## M6-420 / 440 / 450 / 460

**MOTHERBOARD**

**BUS EXPANSION BOARD**

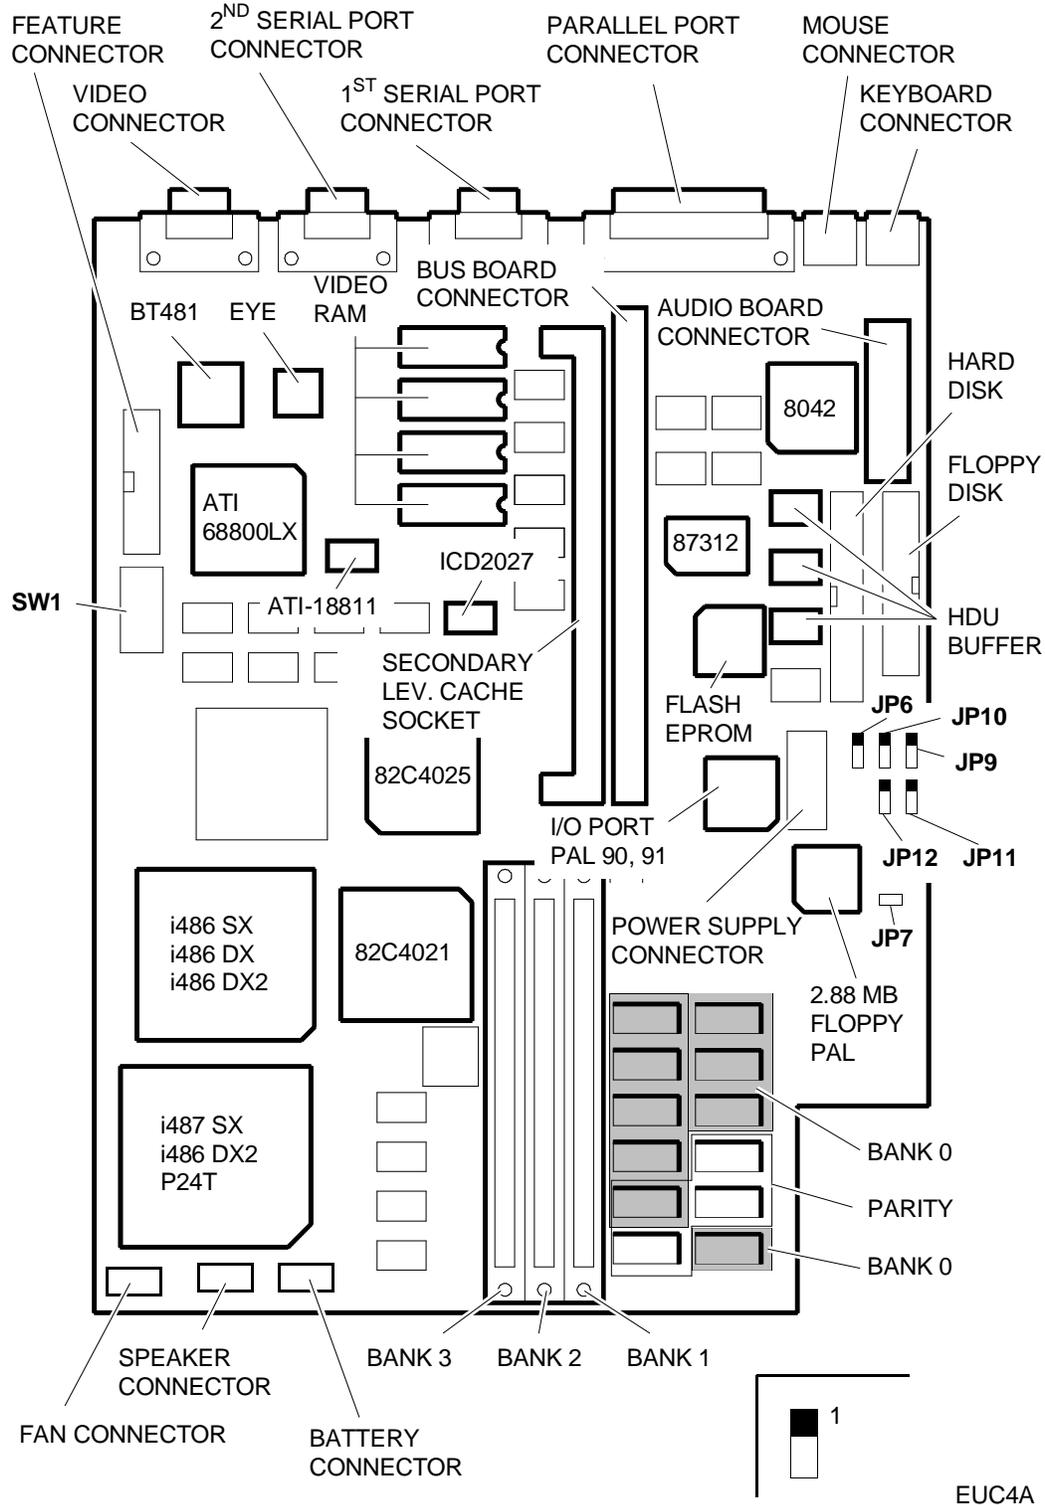
NAME	LEVEL	NOTES
IN2006	Nasc.  Lev. 01	If the interrupt used by the audio board (the available interrupts are 7-9-10-11) is changed in the Windows environment, a message is displayed when exiting the Windows session indicating that the interrupt selected is already used and that interrupt 7 will be remapped. To correct this problem, remove all KRC3 terminators present on side B of the bus expansion board.
